Access Compliance Report

Public Rights-of-Way

Intersection ID: 22381	Main Street: FAIR_VALLEY_DR	Cross Street: SHARON_VIEW_RD	Location:	E
ADA ID: 04391D333CEC	Ramp Type: PerpDiag	Initial Pass/Fail: Fail	Overall Compliance: No	Severity Score: 25

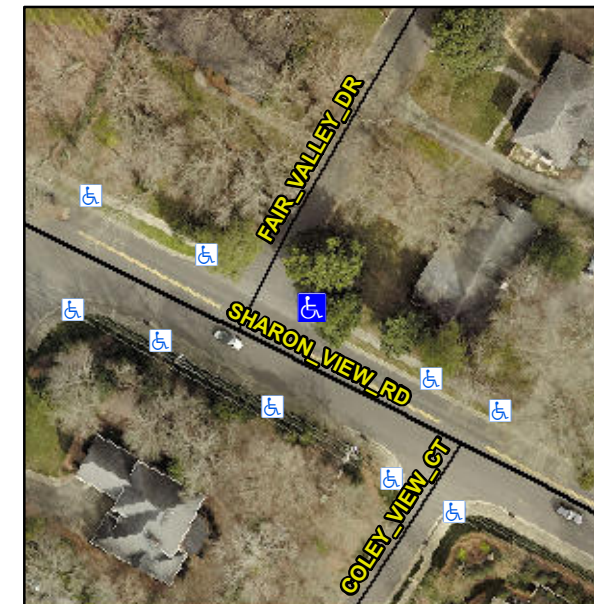
Not Found, R304.2.2, R304.5.3

Compliance	Description	Data	Compliance	Description	Data
N/A	Ramp Length (in)	68.0	No	Ramp Slope (%)	9.6
Yes	Ramp Width (in)	48.0	No	Ramp XSlope (%)	5.8
N/A	Flare Type LT	N/A	N/A	Flare Type RT	N/A
N/A	Flare Slope LT (%)	N/A	N/A	Flare Slope RT (%)	N/A
N/A	Flare Traversable LT?	N/A	N/A	Flare Traversable RT?	N/A
N/A	Landing Length (in)	N/A	N/A	DWS Provided?	N/A
N/A	Landing Width (in)	N/A	N/A	DWS Contrast?	N/A
N/A	Landing Slope (%)	N/A	N/A	DWS Length (in)	N/A
N/A	Landing X Slope (%)	N/A	N/A	DWS Full Width?	N/A
N/A	Landing Curb? (Y/N)	N/A	N/A	DWS Offset (in)	N/A
N/A	Shared Landing?	N/A			
N/A	Gutter Ponding?	N/A	N/A	Gutter Slope (%)	N/A
N/A	Gutter Lip Ht (in)	N/A	N/A	Gutter X Slope (%)	N/A
N/A	Painted X Walk1?	No	N/A	Painted X Walk2?	No
	X Walk 1 Direction	To NW		X Walk 2 Direction	To SW
N/A	X Walk 1 Width (in)	N/A	N/A	X Walk 2 Width (in)	N/A
	X Walk 1 Slope (%)	6.9		X Walk 2 Slope (%)	1.6
	X Walk 1 X Slope (%)	0.8		X Walk 2 X Slope (%)	7.8

Remove & Replace Curb Ramp With Two New Directional Ramps or Equivalent.
